## County of Fairfax, Virginia

### STAFF REPORT

#### APPLICATION PRC C-377

**PROPOSAL:** To construct a 25,679 square foot building addition to the existing school, two new student pick-up and drop-off areas, and other site modifications

**Figure 1: The eroded channel associated with Outfall #3. The channel is identified on the excerpt from Sheet 3 that shows the site's existing conditions. (Source – Fairfax County DPZ Staff Site Visit – April 8, 2012)**

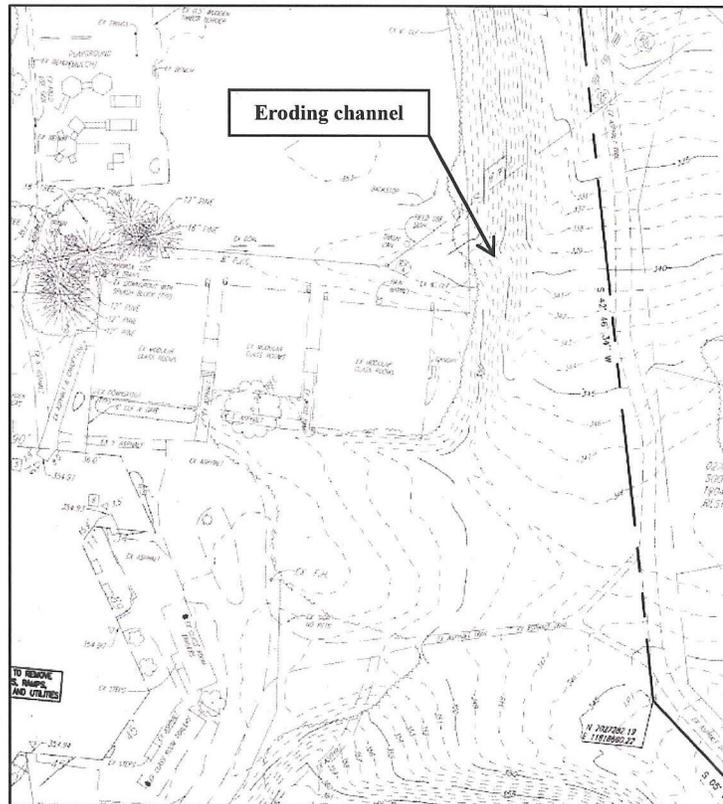
Overall, the PRC plan submitted by the applicant would prevent substantial injury to the use and value of the existing surrounding development. Staff is concerned about the stormwater outfall identified as Outfall #3 on Sheet 8. Outfall #3 is located along the property's southeastern boundary near the asphalt trail that links the W&OD Trail with Cross School Road and the residences along Ramstead Lane (Figure 7). This outfall already has eroded, as seen in Figure 1.

Figure 4: The three locations where temporary classroom trailers would be located if needed due to unforeseen enrollment increases, outlined in blue. (Source – Adtek Engineers, May 4, 2012)

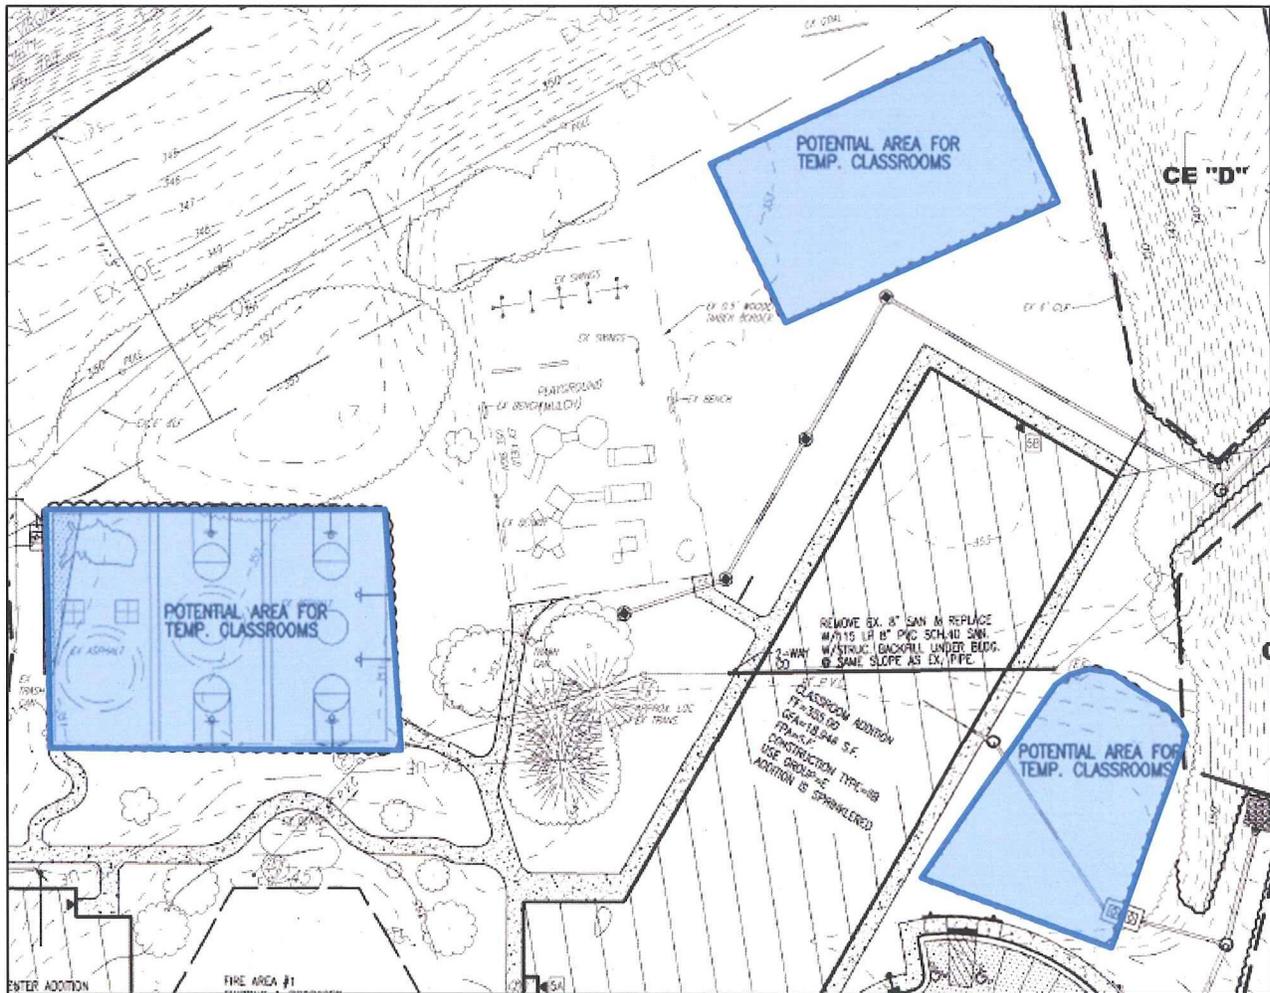
However, the applicant has designated the basketball courts as a potential location for the trailers. This reduces the active recreation space on the site and could create a visual impediment for school staff that are monitoring children during recess. Staff has included a development condition that would permit temporary trailers within the other two areas shown on the PRC plan, or in another location if necessary to meet the Americans with Disabilities Act (ADA) requirements.

10. Irrespective of the potential areas for classroom trailers shown on the PRC plan, should temporary classroom trailers be needed due to unforeseen enrollment increases, the trailers shall not be located within the area identified as the two basketball courts and the adjacent asphalt play area. The applicant may modify the location of the classroom trailers if necessary to meet Americans with Disabilities Act (ADA) requirements.

Figure 10: Outfall #3 shown from Sheet 8 of the PRC plan is identified by the circle. (Source – Adtek Engineers, May 4, 2012)

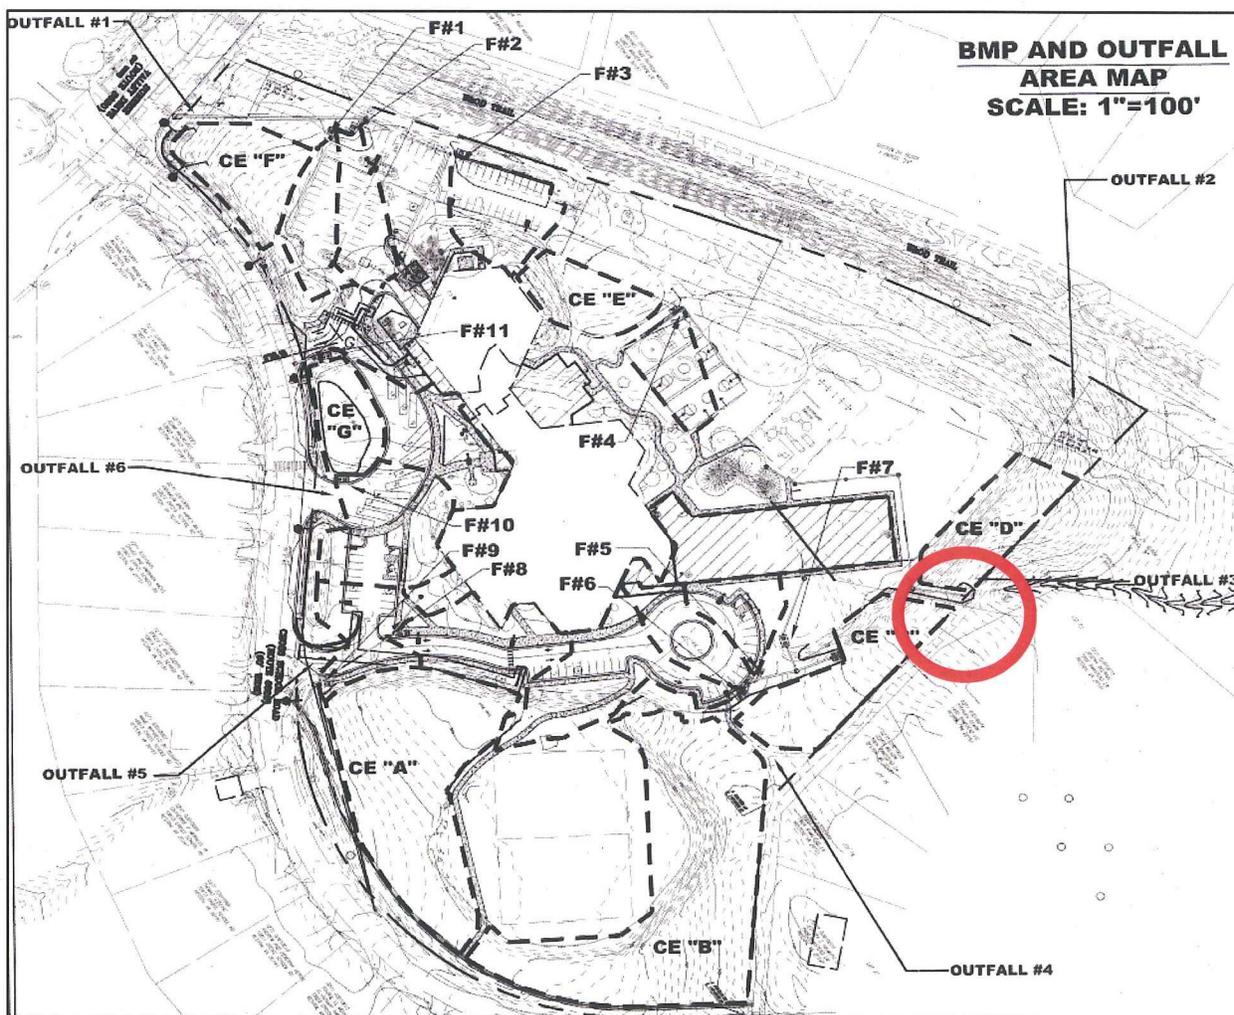
Staff is comfortable with the applicant's off-site approach, subject to final review and approval by DPWES during site plan review (Appendix 10). If after final engineering it is determined that the reinforced ditch would not comply with the PFM's requirements, the applicant should provide on-site detention and show how the channel would be proportionally improved without any adverse downstream effects. Staff has included a condition which addresses the applicant's design and this contingency

13. The applicant shall provide adequate outfall protection for Outfall #3 as specified in the Outfall Narrative on Sheet 8 of the PRC Plan in accordance with the PFM as determined by DPWES at the time of site plan review. In addition the applicant shall show the extent of the ditch that is eroded and provide a typical section and plan view of the stabilization at the time of Site Plan Review. The ditch associated with this outfall shall be stabilized with non-erosive bed and bank reinforcement. In lieu of outfall protection, the applicant may instead provide on-site detention of stormwater and demonstrate a proportional improvement and no adverse impact to the downstream drainage, subject to review and approval of DPWES.
